AGENDA
REGULAR ARCHITECTURAL REVIEW BOARD MEETING
Public Meeting Room, Village Hall
Tuesday, September 27, 2016
7:00 p.m.

Subject:	Lincolnshire Marketplace Retail Development (Downtown)
Action Requested:	Consideration of Proposed Development Plans for Culver's Restaurant and Lincolnshire Marketplace Shopping Center Ground Signs
Petitioner:	Lincolnshire Marketplace LLC
Originated By/Contact:	Tonya Zozulya, Economic Development Coordinator Department of Community & Economic Development
Advisory Board Review:	Architectural Review Board

Subject:	Lincolnshire Marketplace Retail Development (Downtown)
Action Requested:	Design Workshop on Proposed Development Plans for Culver's Restaurant and Lincolnshire Marketplace Shopping Center
Petitioner:	Lincolnshire Marketplace LLC
Originated By/Contact:	Tonya Zozulya, Economic Development Coordinator Department of Community & Economic Development
Advisory Board Review:	Architectural Review Board

SIGN
TABULATION PLAN
SCALE: 1/100" = 1'-0"

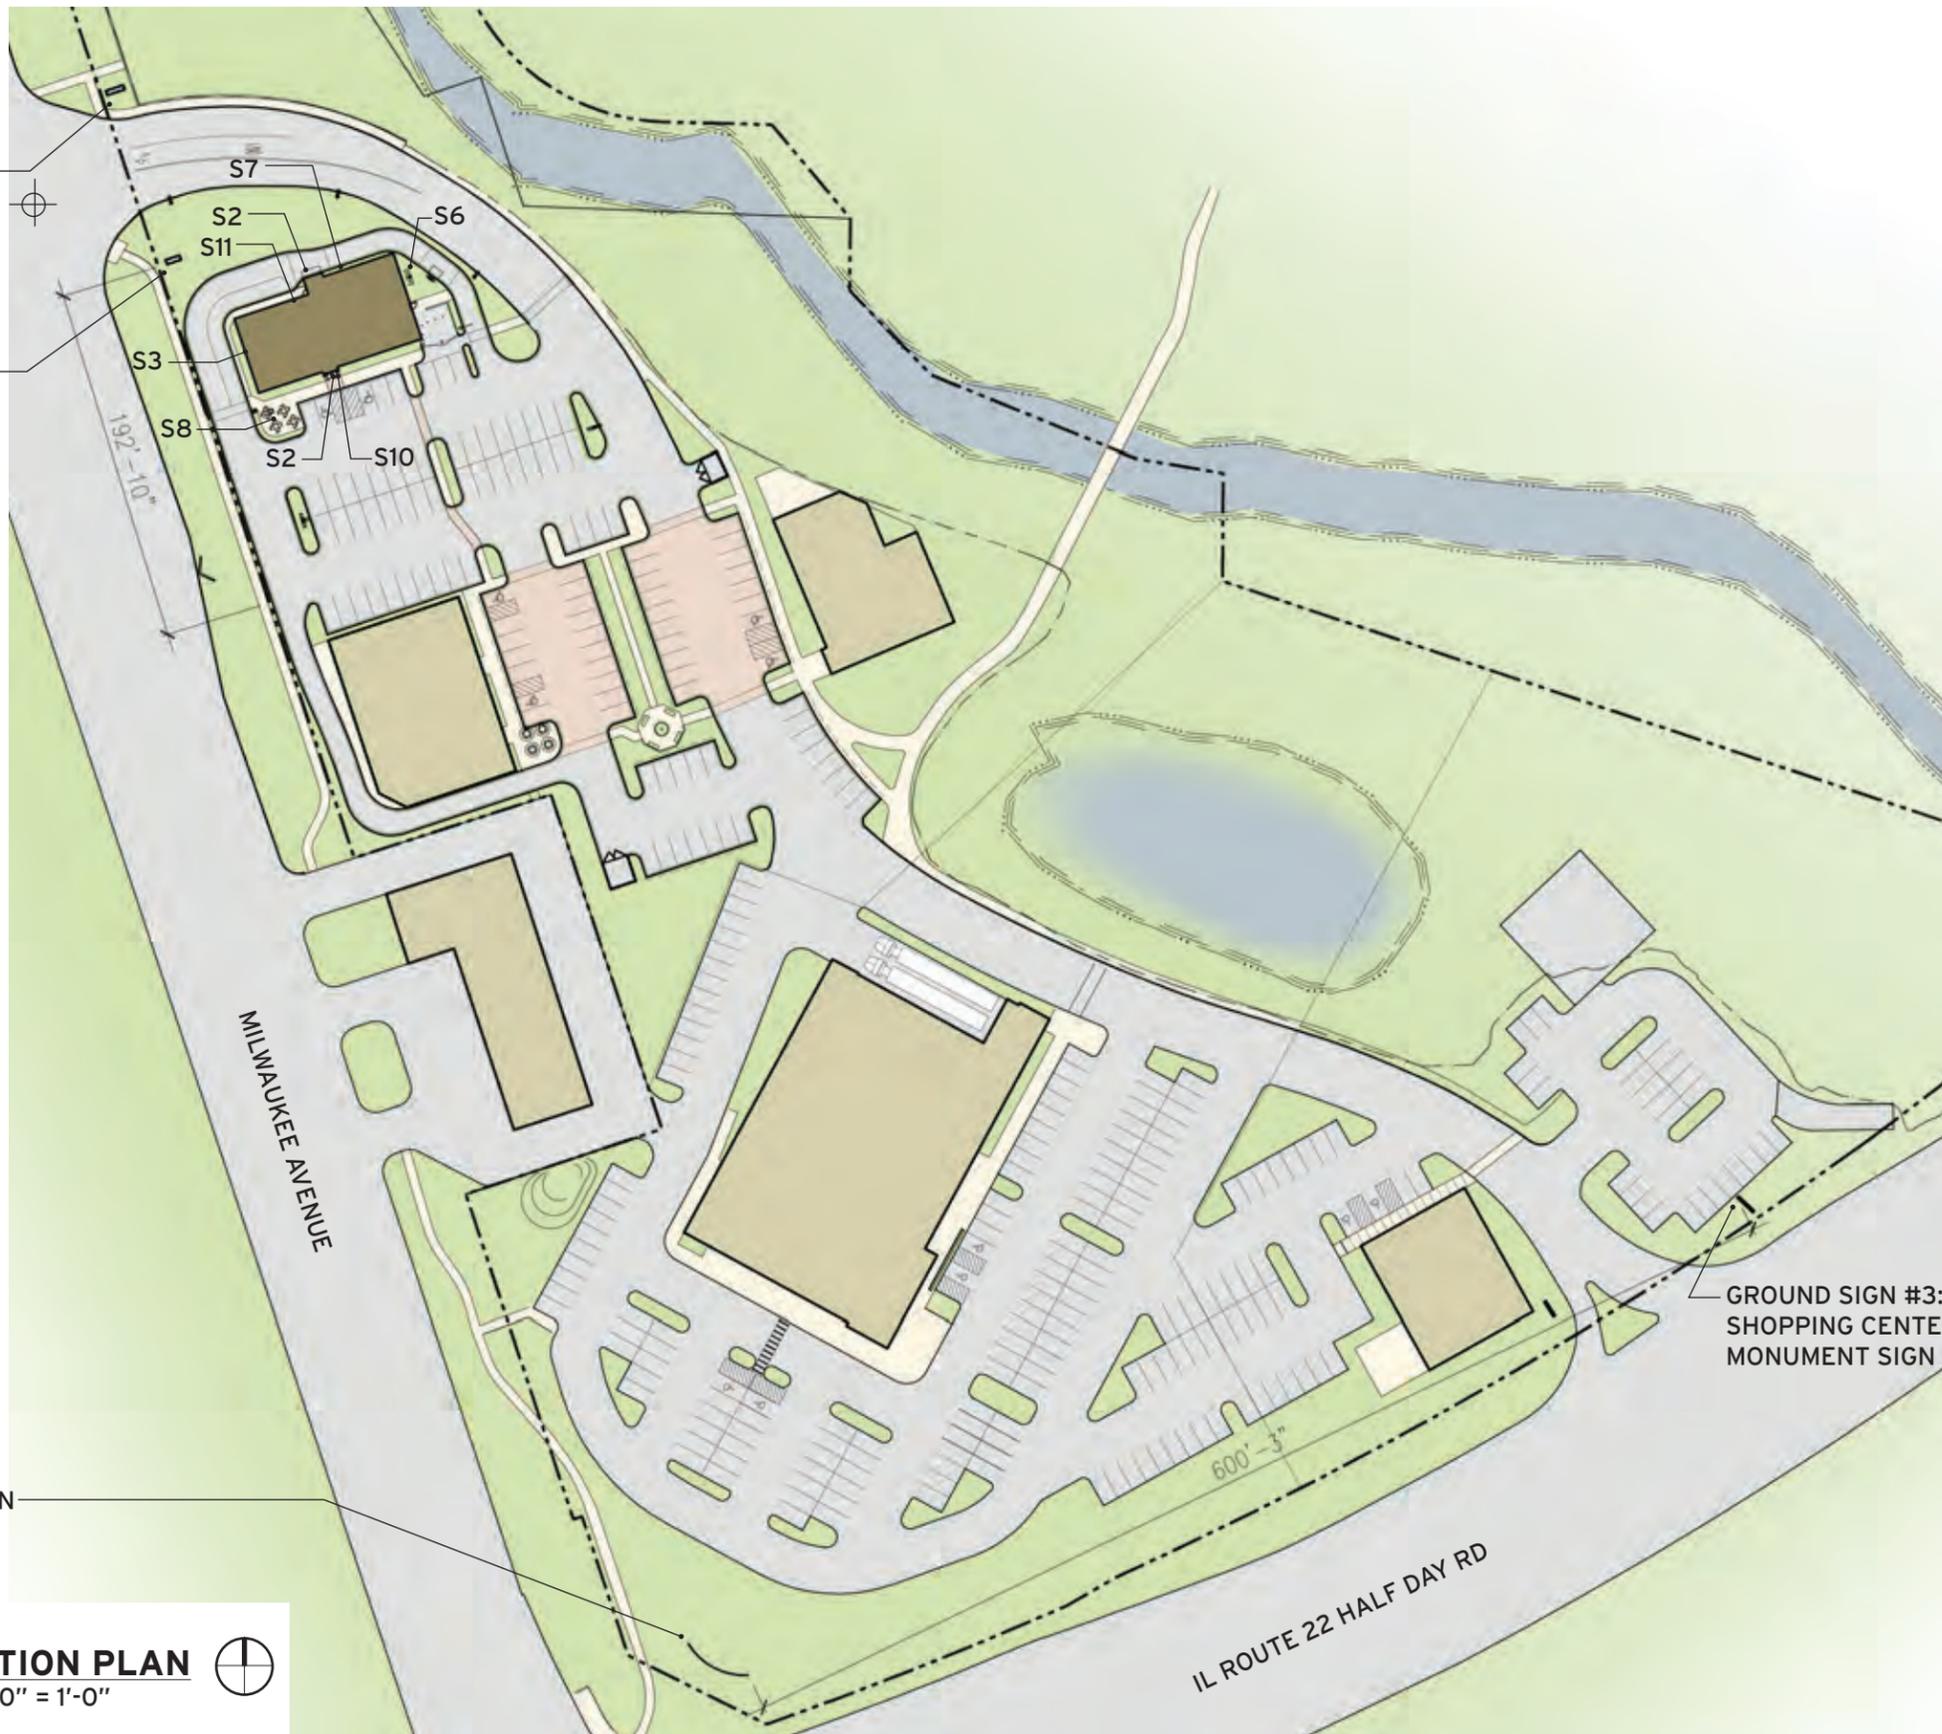
6. Provide a manual changeable "flavor of the day" copy as an alternative to the proposed electronic message board for Culver's ground sign.
 7. Relocate the proposed Milwaukee Avenue shopping center sign further north, across the spine road.

Upon review of the proposed ground sign locations, the Village Engineer identified easement and sewer line conflicts. Therefore, the locations noted in the attached presentation packet are subject to change. This information has been communicated to the petitioner to consider relocation of the proposed signs.

- The Milwaukee Avenue shopping center monument sign has been relocated to the north side of the spine road. The existing sidewalk in the area has been relocated to allow for the proposed sign.
- The signs have been modified by eliminating the double-column tenant sign panel and increasing the width of the sign panel.
- The attached shopping center tenant signage criteria has been revised.

S1a

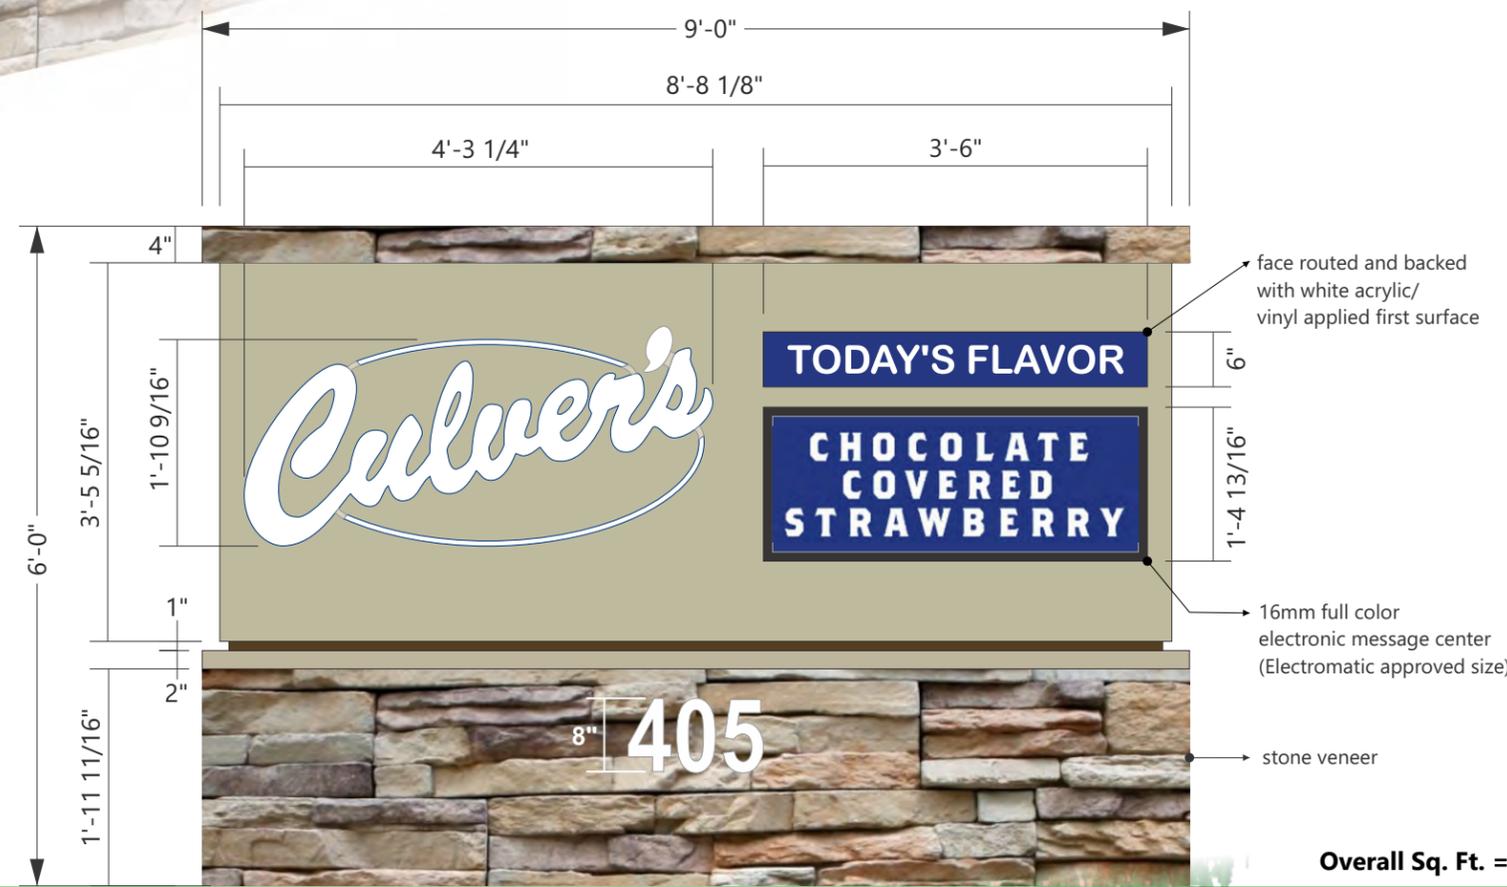
- Evaluated the proportion of the items on the monument sign – Culver's would like the ARB to consider option S1a which provided for better visibility with the electronic message center (EMC). There are two other options which provide for various dimensions for the EMC, however they don't provide the same degree of visibility along Milwaukee Avenue.
